# MIAMI BEACH

PLANNING DEPARTMENT  
Staff Report & Recommendation

Design Review Board

SUBJECT: DRB21-0739  
**291 Palm Avenue**

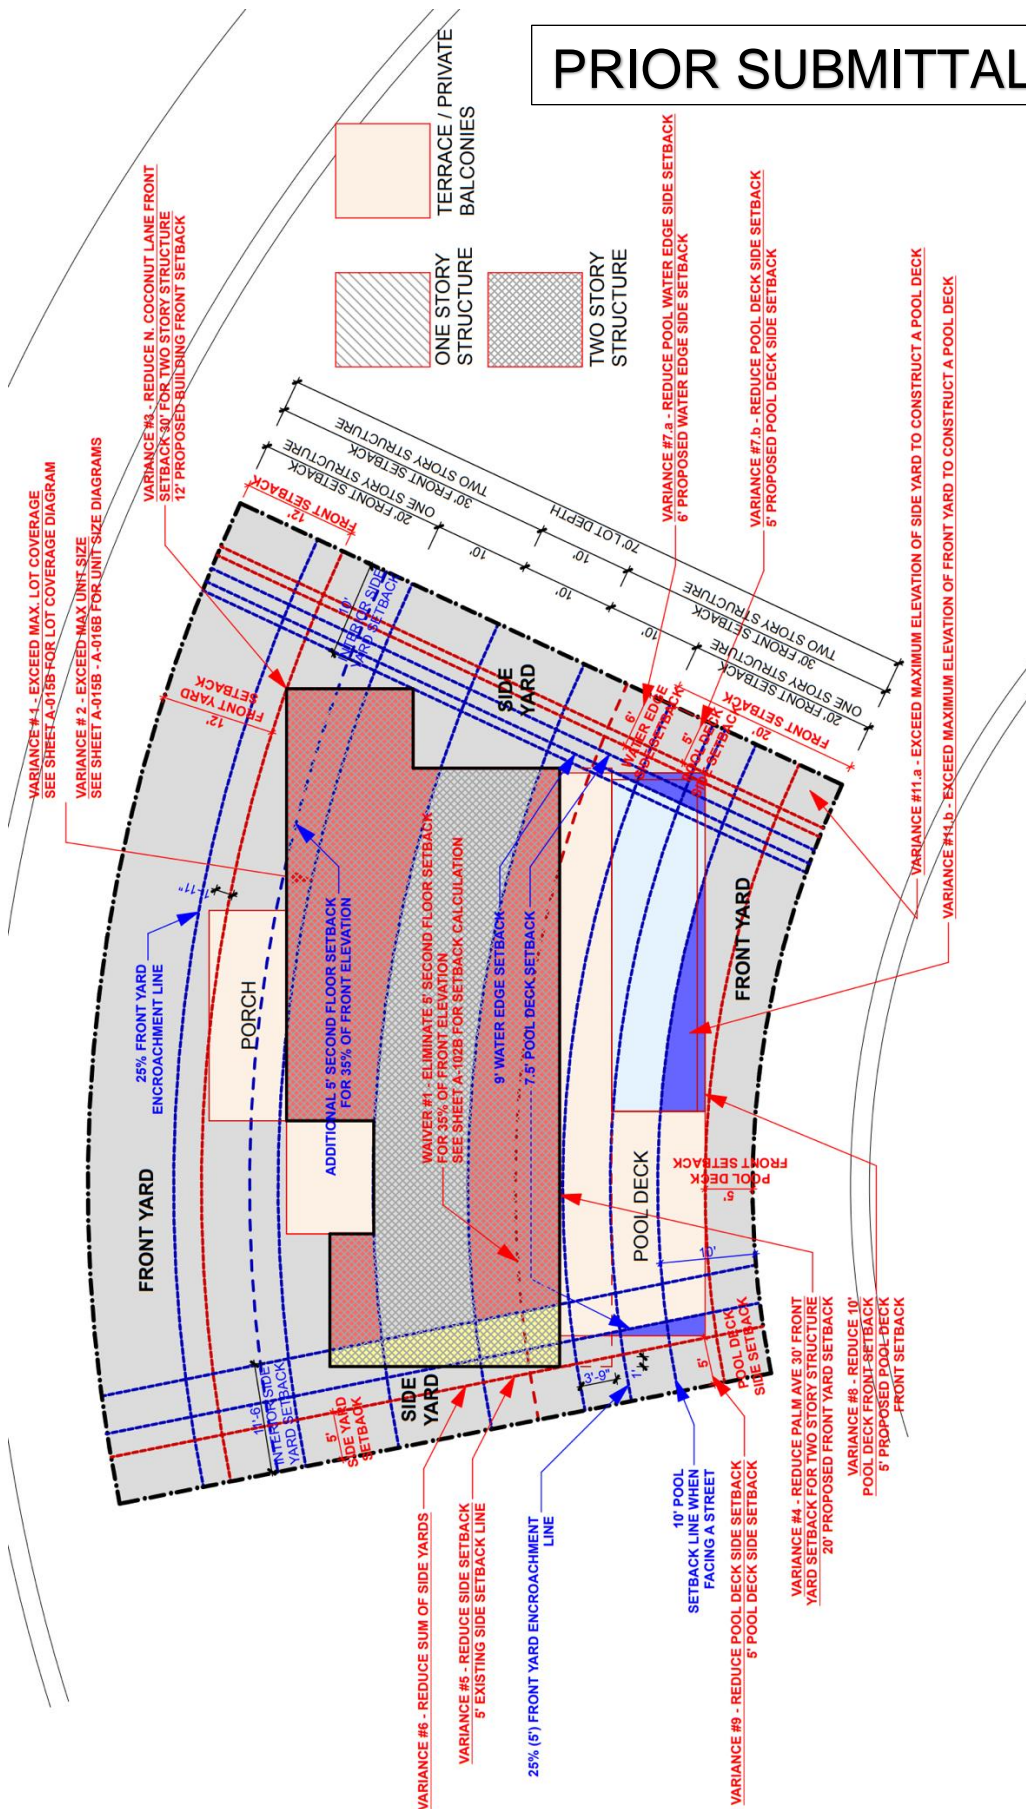
Due to the complexity and number of variances requested, staff has included below some of the variance diagrams provided with the application. The diagram below, from Sheet A-019 of the application, outlines the general setback requirements for the two single family lots resulting from the lot split application approved by the Planning Board on October 26, 2021. 'Lot B Revised' is the subject lot that is part of this application.

This lot is rather unique in that it has a curved trapezoidal shape, with two street fronts and is also very shallow, with a lot depth of only 70 feet. Most single family lots on Miami Beach have a lot depth of at least 100 feet. The diagram below shows that absent any relief from the City code, with the current required setbacks, the maximum width of a single-story home is 30 feet, and the maximum width for a 2-story home is only 10 feet. This shallow lot depth, as well as the unique bean shape of the lot, does present a hardship for the construction of any home on the subject site.

Although supportive of the majority of the variances requested, as noted below, due to the unique shape and depth of the lot, staff continues to believe that the applicant is attempting to place too much mass on the site, which is further exacerbated by the number of variances requested. For this reason, staff is recommending a slight reduction in the maximum unit size (from the requested 50% down to 45% - **Variance #2**) and from the requested lot coverage (from the requested 31.2% down to 30% - **Variance #1**). These two variance requests have not changed since the prior meeting.

Staff would also point out that the existing 2-story home (although much lower in height than the proposed new home) has a setback of around 5 feet for a large frontage of the home along North Coconut Lane. Again, based upon the hardship presented by the unique shape and depth of the lot, staff is supportive of the requested variances related to the primary setbacks of the home (**Variances #3 & #4**), including the proposed interior side setback and sum of the side yard setbacks (**Variances #5 & #6**).

PRIOR SUBMITTAL

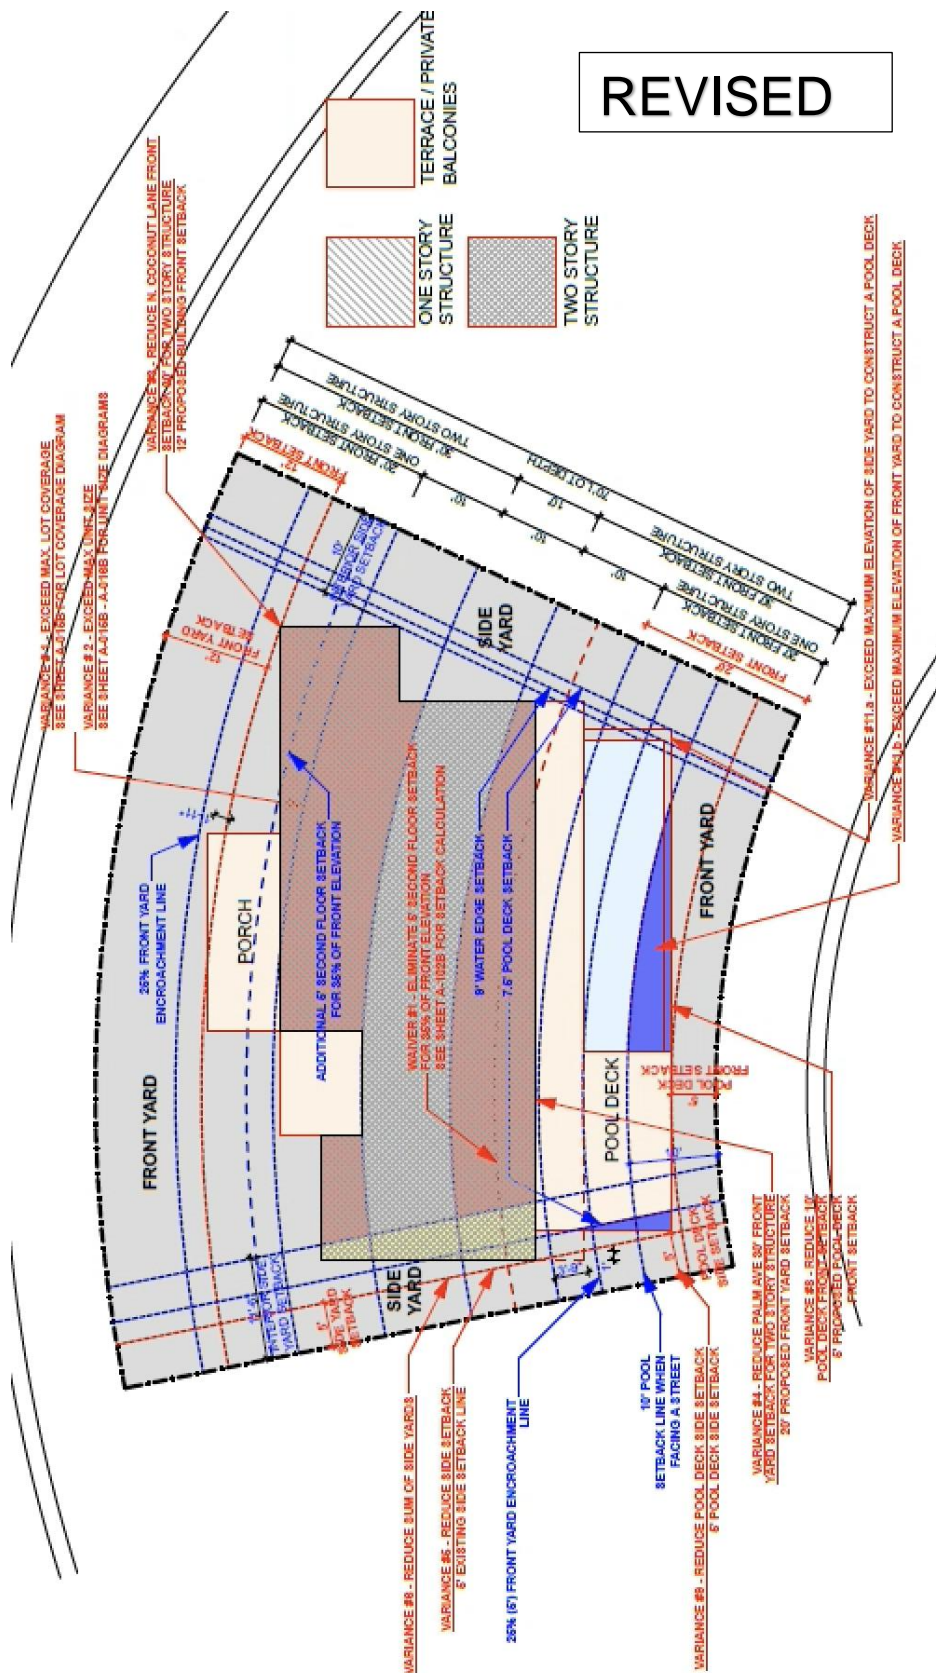
1. A variance from Sec. 142-105(b)(9)(a) to exceed by 6.2% (512 SF) the maximum lot coverage allowed of 25% (1,503 SF) for a lot resulting from a lot split in order to construct a new two-story residence with a lot coverage of 31.2%. (1,879 SF).  
**Modification recommended (30% total lot coverage)**
2. A variance from Sec. 142-105(b)(9)(b) to exceed by 10% (605 SF) the maximum unit size allowed of 40% (2,404 SF) for a lot resulting from a lot split in order to construct a 3,009 SF two-story home with 50% total unit size.  
**Modification recommended (45% total unit size)**
3. A variance from Sec. 142-106(a)(1)(b) to reduce by 18'-0" the minimum required 30'-0" front setback to construct a new two-story structure from the front property line facing North Coconut Lane with a 12'-0" setback.  
**Approval recommended**

4. A variance from Sec. 142-106(a)(1)(b) to reduce by 10'-0" the minimum required 30'-0" front setback to construct a new two-story structure from the front property line facing Palm Avenue with a 20'-0" front setback.

**Approval recommended**
5. A variance from Sec. 142-106(a)(2)(c)(1) to reduce by 5'-0" the minimum required setback of 10'-0" from an interior side property line in order to construct a new two-story structure with a 5'-0" setback.

**Approval recommended**
6. A variance from Sec. 142-106(a)(2)(a) to reduce by 10'-0" the minimum required sum of the side yard of 25'-0", in order to provide a sum of the sideyards setback of 15'-0".

8. A variance from Sec. 142-106(b)(16)g to reduce by 5'-0" the minimum required 10'-0" setback in the front yard to construct a pool deck.  
**Approval recommended**

9. A Variance from Sec. 142-106(b)(16)b.1 to allow a pool's deck in the west interior side yard with a setback of 5'-0" where 7'-6" is required. **Variance request modified.**

**Approval recommended**
10. A Variance from Sec. 142-105(b)(6) to allow the habitable roof deck to be set back 8'-4" and 4'-10" to the north and south respectively when 10'-0" is required.

**Approval recommended**
11. A Variance from Sec. 142-105(b)(8)b.1 to exceed maximum elevation of side yard to construct pool deck and front yard at 10' NGVD.

**Variances #7, #8, and #9** relate to the setback requirements for the pool and pool deck. Due to the irregular shape of the lot, minimal lot depth, and because the lot has two frontages, staff is supportive of the variances for the western side of the lot, which abut the companion lot that was part of the lot split process. As the eastern side abuts an existing property, staff previously recommended that the pool and pool deck on the eastern side of the site comply with the setback requirements so that the abutting neighbor is not negatively impacted by the proximity of the pool deck. The applicant has revised the plans and variance request to comply with this recommendation.

**Variance #10** is for the setback requirements for the roof deck facing both Palm Avenue and North Coconut Lane. The deck exceeds the setback requirements on the east and west sides. Due to the narrow width of the building, which is a result of the unusually shallow property depth, staff recommends approval of this variance due to the practical difficulties presented based on the size and shape of the lot.

**Variance #11** is for the height of the pool deck within the front yard facing Palm Avenue as well as the interior side yards. An elevation of 10'-0" is requested where the maximum height is 7.5 feet (grade + 30 inches). The City Code allows rear yards of waterfront lots to be constructed at the same finished floor of the house, up to BFE+ 5 feet. However, this allowance is not provided for a non-waterfront property. As this is a vacant site, and provided that the setbacks noted above are approved by the Board, a pool can be constructed in the functional rear of the house at the maximum elevation allowed by the City Code. As such, staff recommends denial of the requested variance, due to lack of hardship or practical difficulty.

**Denial recommended**
